Docket Item # 2
BAR CASE # 2009-0090

BAR Meeting
May 27, 2009

ISSUE: Alterations
APPLICANT: Scott Binde
LOCATION: 1307 Queen Street
ZONE: RB/Residential

BAR CASE #2009-0090

Figure 3. Proposed front facade.

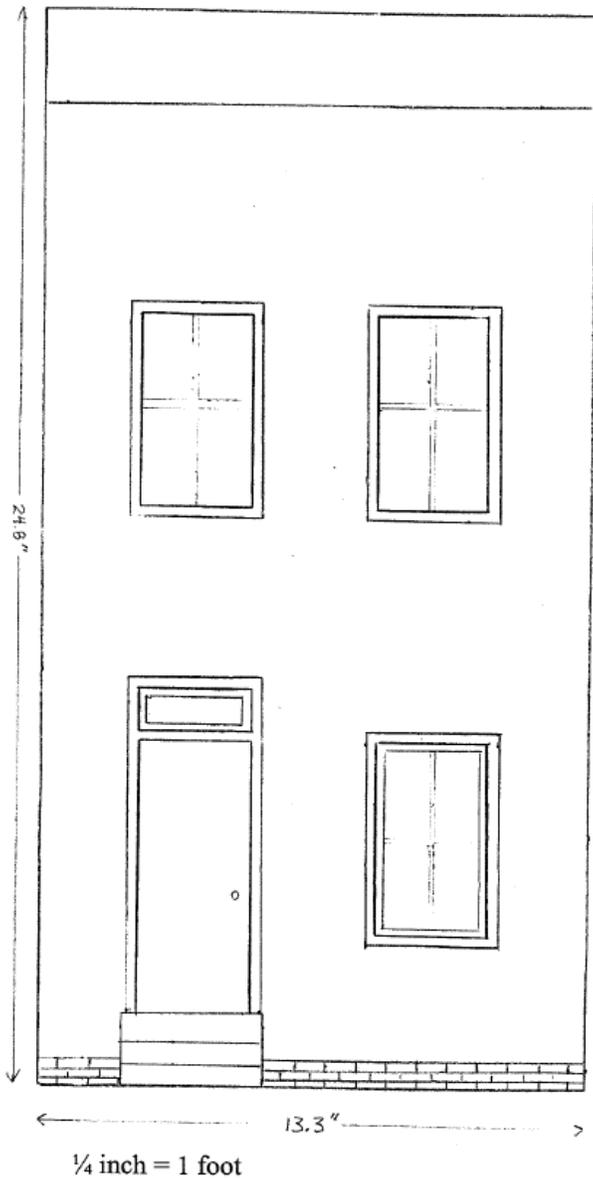
Given the obvious alterations to the front façade, Staff cannot determine if there was originally a transom above the front door. Given the prevalence of transoms for late 19th/early 20th century houses, and the existence of many transoms in the immediate vicinity of 1307 Queen Street, Staff does not object to the installation of the transom.

1. That the wood windows on the front and side (west) elevation of the main block are single glazed, with true divided lights;
2. That the wood windows on the narrow north elevation of the main block and the rear ell may be double glazed with simulated divided lights;
3. That the main block of the house be clad with 6" reveal beveled wood siding; and,
4. That smooth Hardiplank may be installed on the rear ell provided that the nails not show in the installation of the siding.
